Re: Proposed Concepts for Commercial
Harbor Craft in California

Appendix A
Jensen Naval Architects and Marine Engineers: Engineering Review Summary - Cal Maritime
Tier 4 Feasibility Study

Engineering Review - Cal Maritime Tier 4 Feasibility Study

Engineering Review Summary

Figure 1: Crowley Tug SCR Arrangement

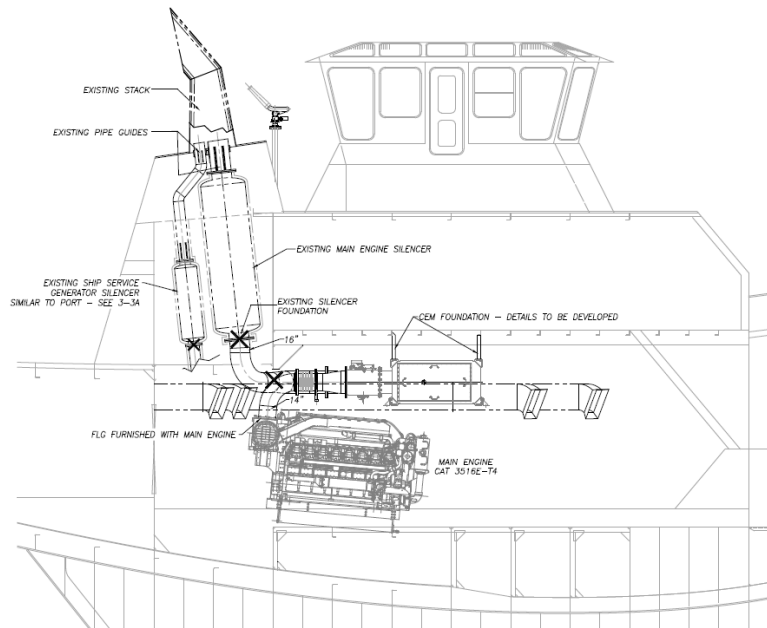
- The tug is fortunate to have the available space in the overhead of the engine room so the SCR's were located above the main engines as shown in Figure 1.

Figure 2: Example of SCR Located in the Stack

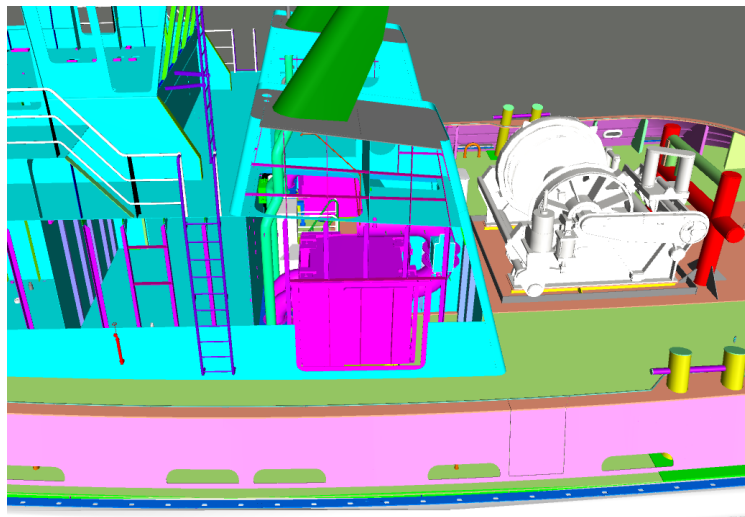
As described above, the engine room of a ship assist and escort tug may not allow for the installation of SCRs in the overhead. In these cases, the SCRs may need to be located in the stacks which requires more extensive structural modifications and typically has an impact on the engine room ventilation fan arrangement. This can also create challenges in accessing the SCR for routine maintenance. Figure 2 shows an example of an SCR located in the stack. Note that this was excerpted from a new design.
